A Review of Combat Helmet Acceptance Testing

O.C. Curves: 0/20 and 17/240 plans

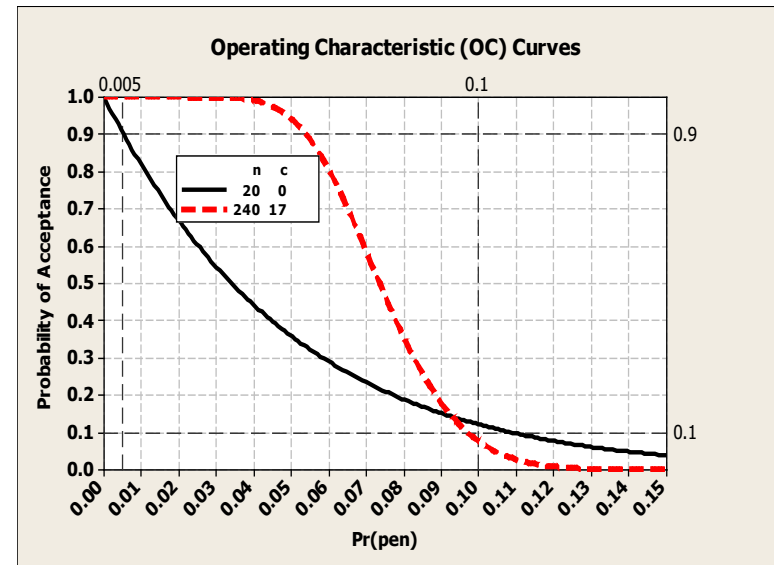
Manufacturer's Incentive

- To have 90% chance of passing acceptance test

Plan pen-prob

- 0/20 .005

- 17/240 .055

Current Data

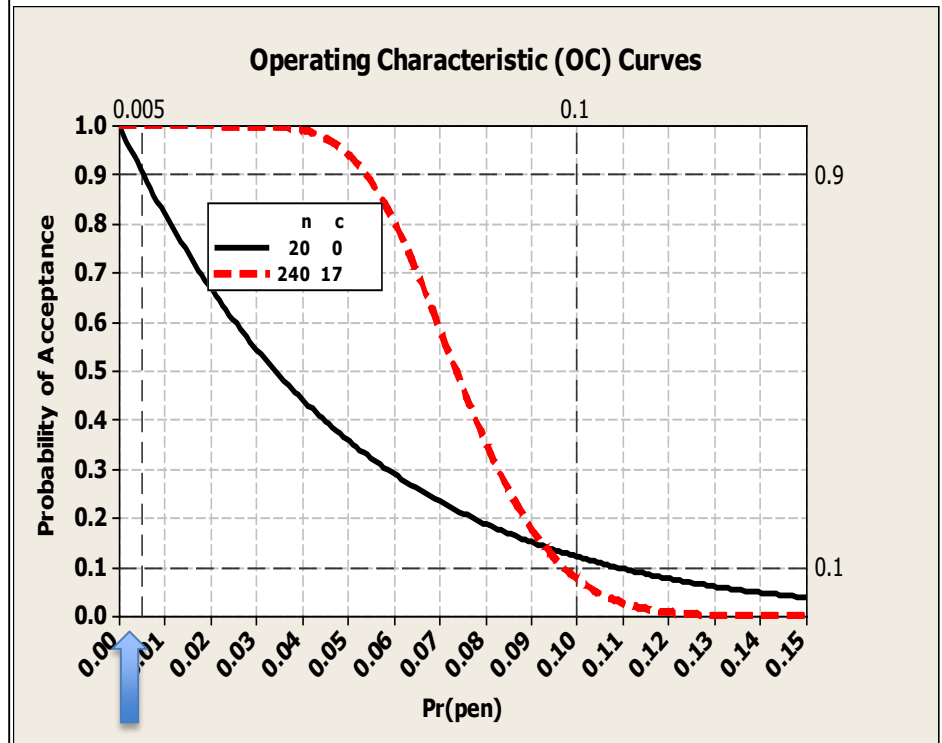
Mfgs. about 100x better than the 10% pen-prob "standard"

- There is no scientific or empirical basis for setting pen-prob = .10 as a 'standard'; current helmets much better
- Acceptance test should be designed to provide adequate assurance that new helmets are *not more penetrable than existing helmets*
- **17/240 does not meet that criterion. Helmet 10x current helmet pen-prob would be very likely to be accepted.**

H1: BFD by Shot Loc. and Env. vs. Spec Limits of 25.4 and 16.0 mm

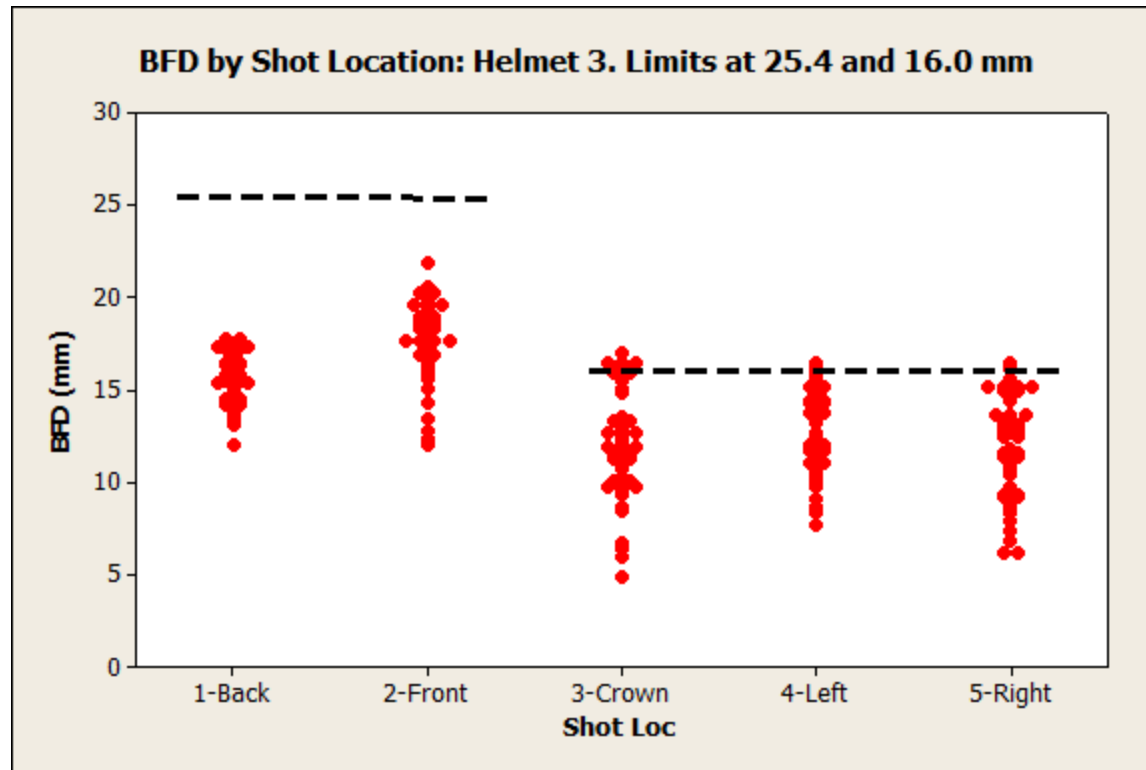
Note. A 20 mm dent in your head is OK, front or back, but not left, right, or crown.

H3: BFD by Shot Loc. vs. Spec Limits

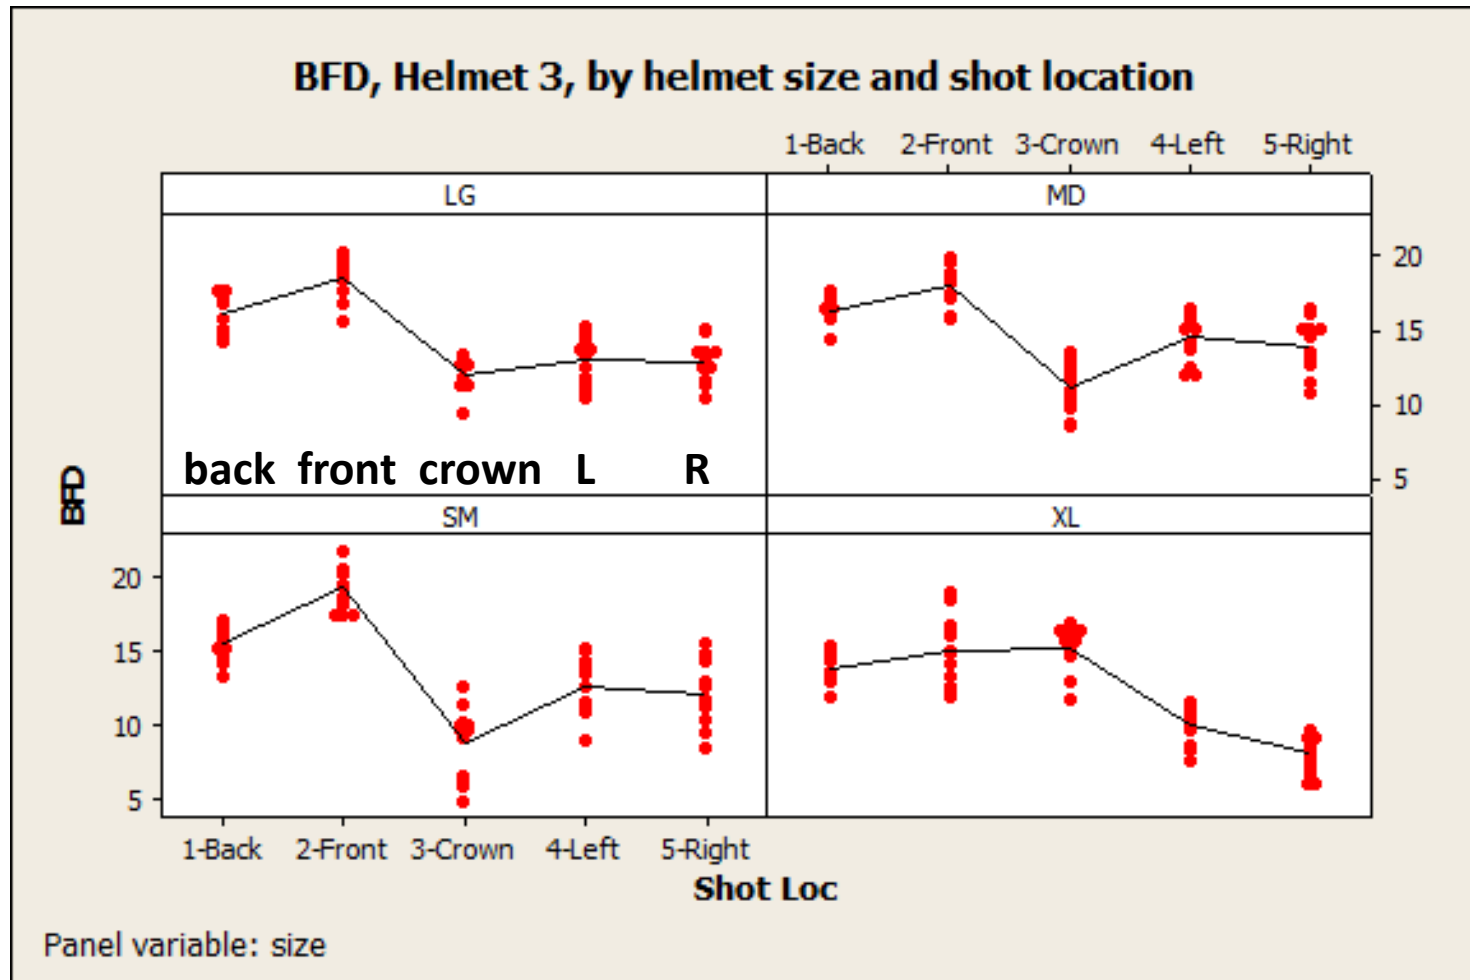
a few exceedances, << 10%
